SUBJECT: MEETING NOTIFICATION AND TRANSMITTAL OF TENTATIVE AGENDA

MAG Standard Specifications and Details Committee
TENTATIVE AGENDA
January 6, 2016

MEETING MINUTES FROM THE
MARICOPA ASSOCIATION OF GOVERNMENTS
STANDARD SPECIFICATIONS AND DETAILS COMMITTEE

DETAIL NO. TBD- 2	 MARICOPA ASSOCIATION of GOVERNMENTS STANDARD DETAIL ENGLISH	RECLAIMED WATER VALVE BOX INSTALLATION	REVISED 3/4/15 Draft	DETAIL NO. TBD- 2
-----------------------------	---	---	-------------------------	-----------------------------

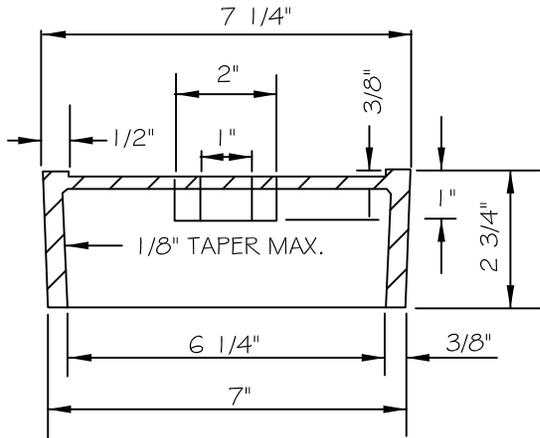
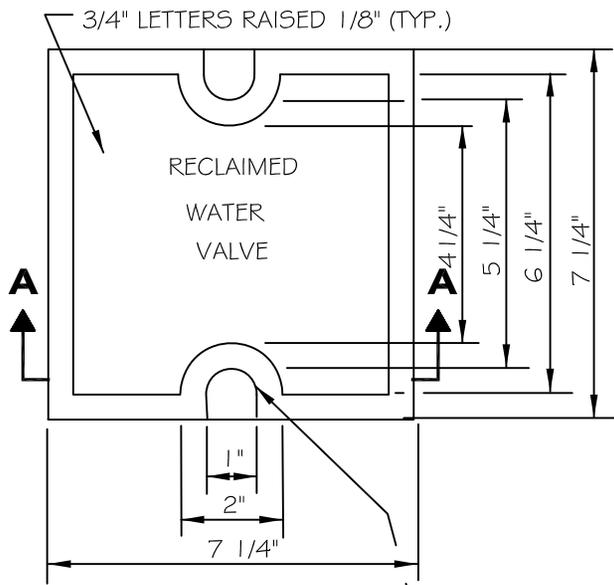
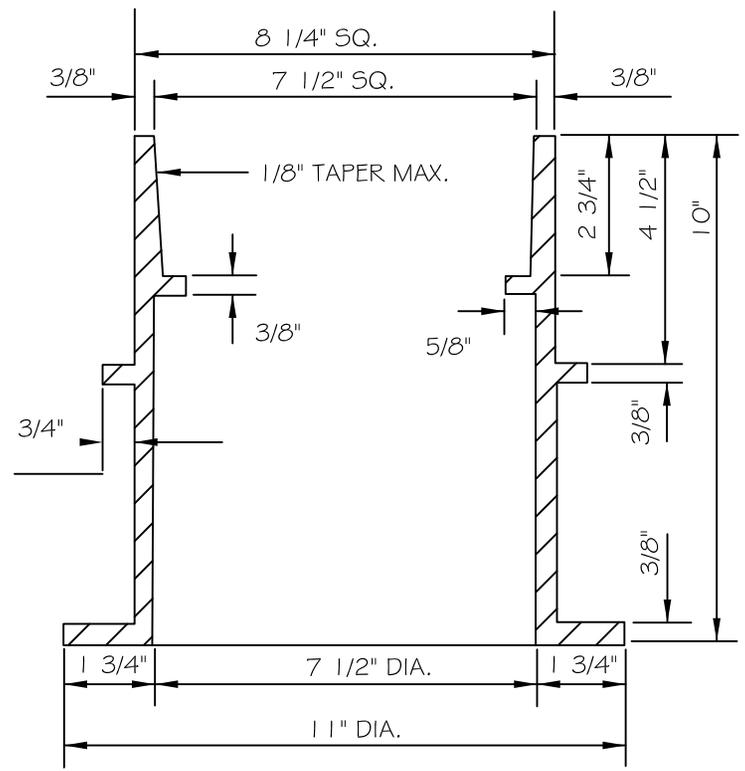
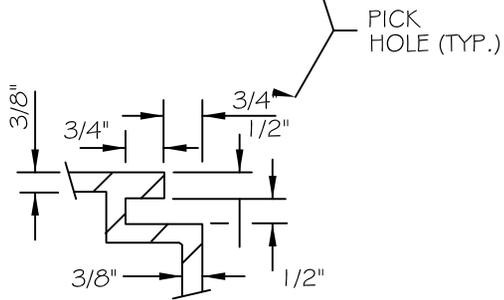
Valve boxes shall be in accordance with Section 345, this Section and Detail 391-1, ~~and 391-2~~ and TBD.
Manholes shall be in accordance with Section 625, 787 and this Section, and applicable Details.

2. New Reclaimed Valve Box Detail No. TBD

See attached initial DRAFT for further development.

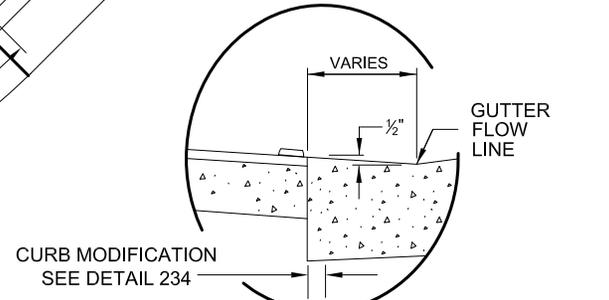
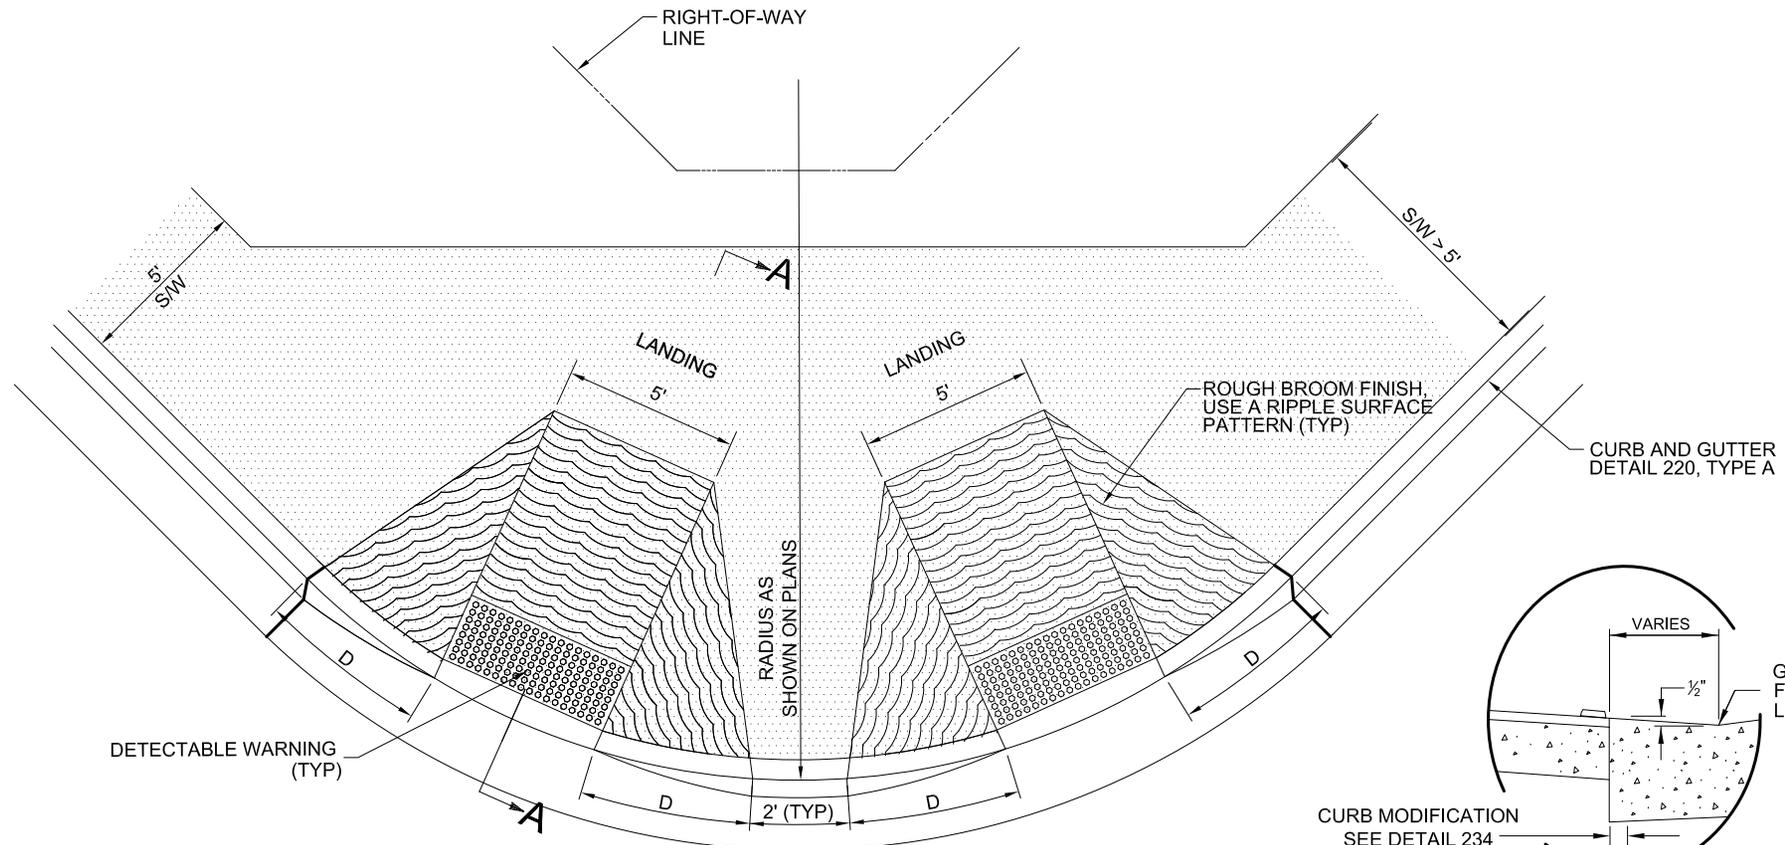
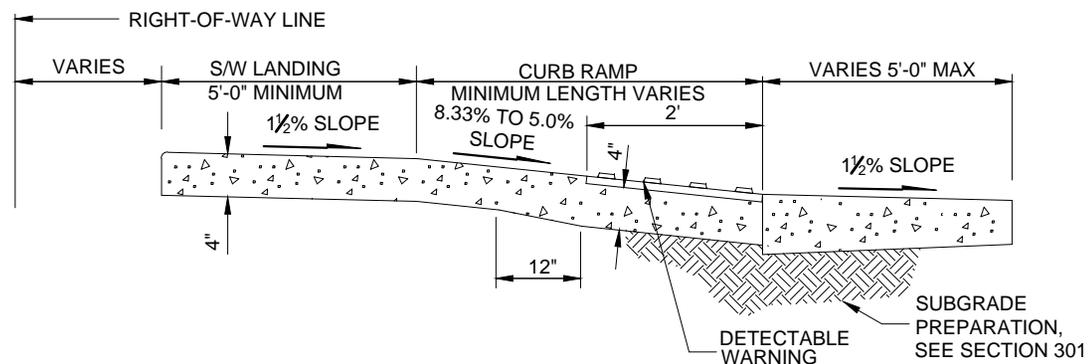
The group next reviewed the directional ramp detail. Mr. Forrey noted that several dimensions still needed to be determined. Mr. Wilhite asked why the detectable warnings did not meet the edge of the curb. He also drew a diagram on the whiteboard to help explain how in order to have both a 1.5% slope at the bottom of the ramp to avoid debris collection, and an 8.33% slope on the ramp, some cross-slope of the ramp may be required depending on the direction of the flowline of the curb. Members also thought it would make sense to show the curb in the section view to be consistent with other details, and adjust placement of the section line. Mr. Wilhite

asked if the concrete was scored to help visualize the flow line. Mr. Tyus thought the inner line at the bottom of the ramp could be removed. Tom Wilhite provided written comments on the draft detail and also suggested adding Note #6 from Tempe's detail.

Warren White and Brandon Forrey said they would incorporate comments and feedback to update the draft details. The group suggested that Mr. White provide an update to the committee on the working group's progress and get some initial feedback from them as well.

DETAIL NO.
236-1

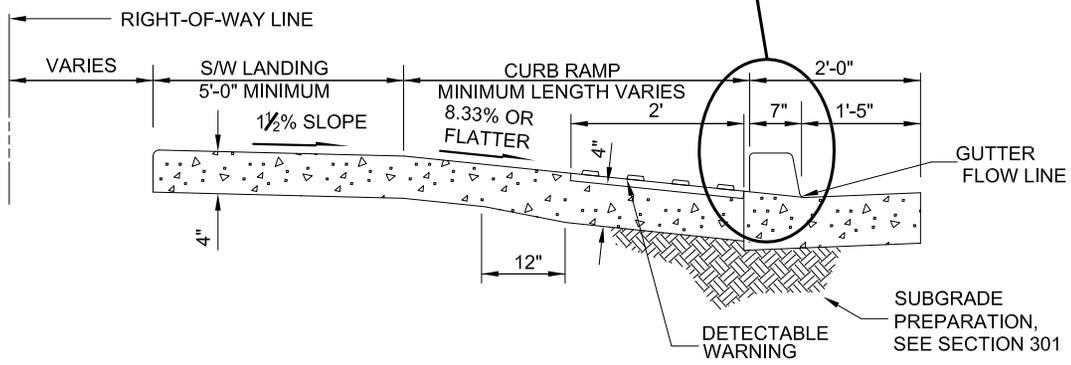
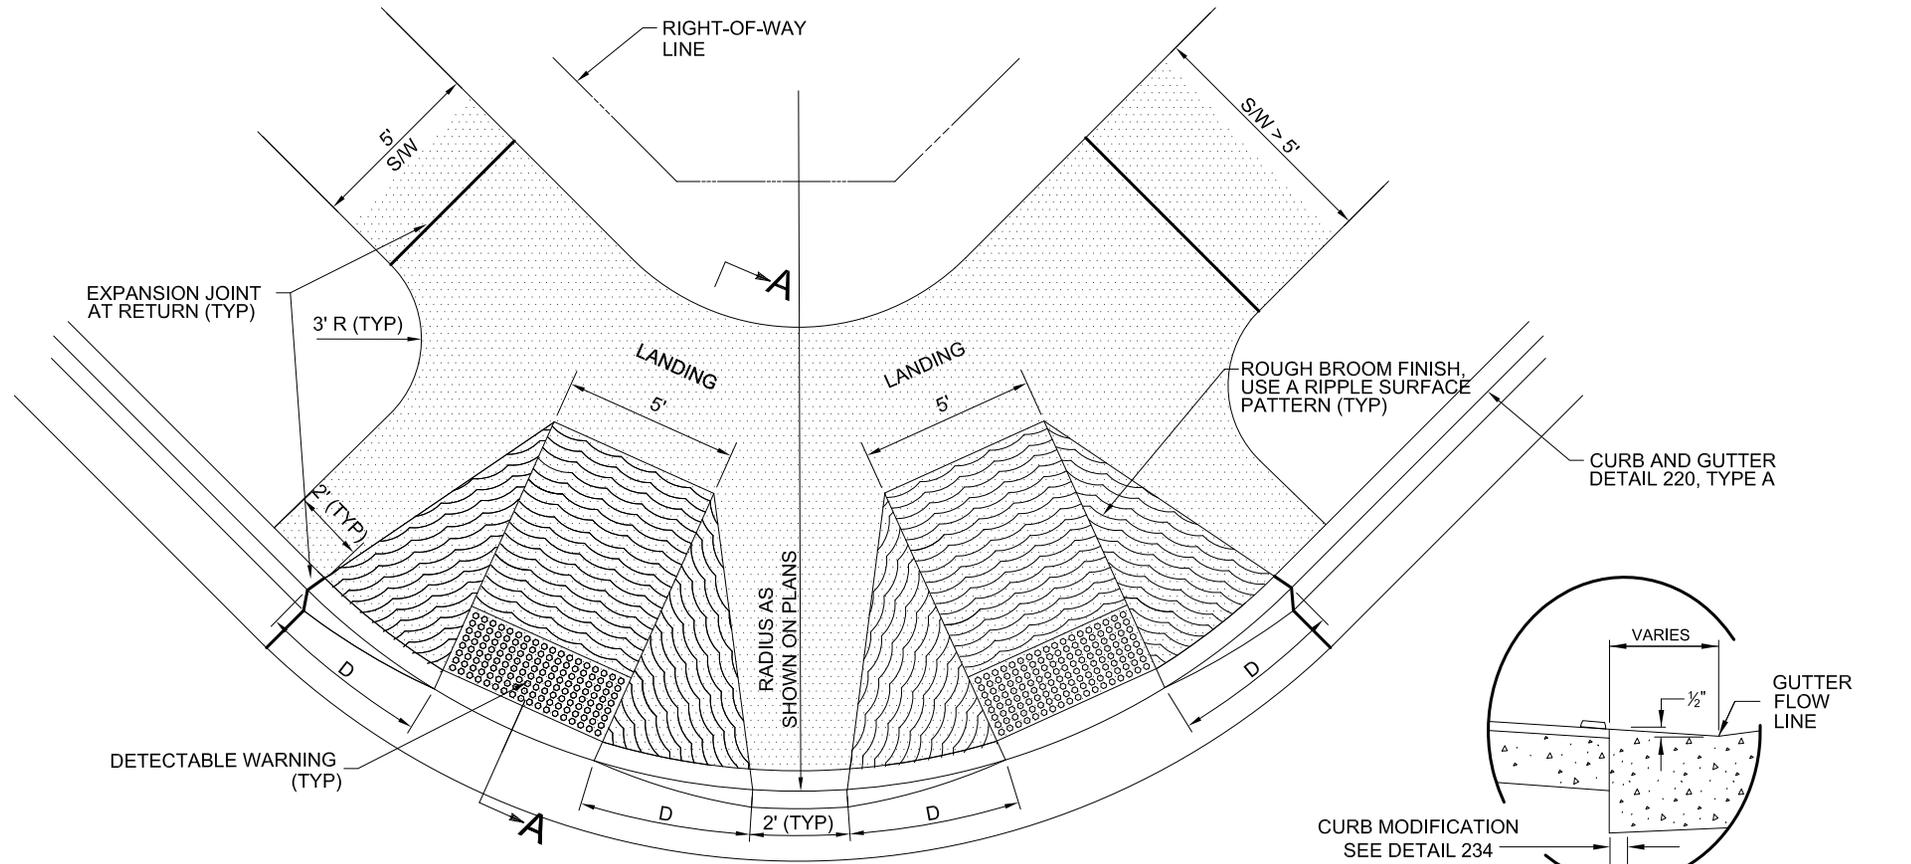
Mr. White handed out the latest drafts of dual curb ramp options: Detail 236-1 was a modification of existing Detail 235-1 showing radial ramps for an attached sidewalk. Detail 236-2 showed radial ramps for a detached sidewalk. Brandon Forrey provided a draft Detail 237-1 that showed directional dual ramps in a format similar to existing MAG details. Mr. Gordon asked why we were developing radial ramps if the directional ramps are preferred. Mr. Forrey stated that the radial ramps are still allowed under the proposed guidelines, and it would be good to have several options available for agencies to choose from. He said that even single ramps are allowed in certain retrofit situations. Ms. Hollow said that projects that use ADOT federal funds are required to use dual ramps.

For the radial ramps Mr. Wilhite provided written notes adding some dimensions. There was discussion about what minimum sidewalk widths should be shown on the details. He also shared Tempe's details with the group. Mr. Forrey commented that providing all the options for sidewalks widths, street radii and curb thicknesses all on one drawing was tricky. Mr. Tyus developed a 3D model of the existing MAG detail 235-1 to visualize it to scale and suggested that the draft 236 details show wider wings and more separation between ramps for a more realistic look. There was discussion on making the distance between ramps 2' minimum instead of typical, since the ramp placement changes based on the radius of the street and placement of crosswalks.
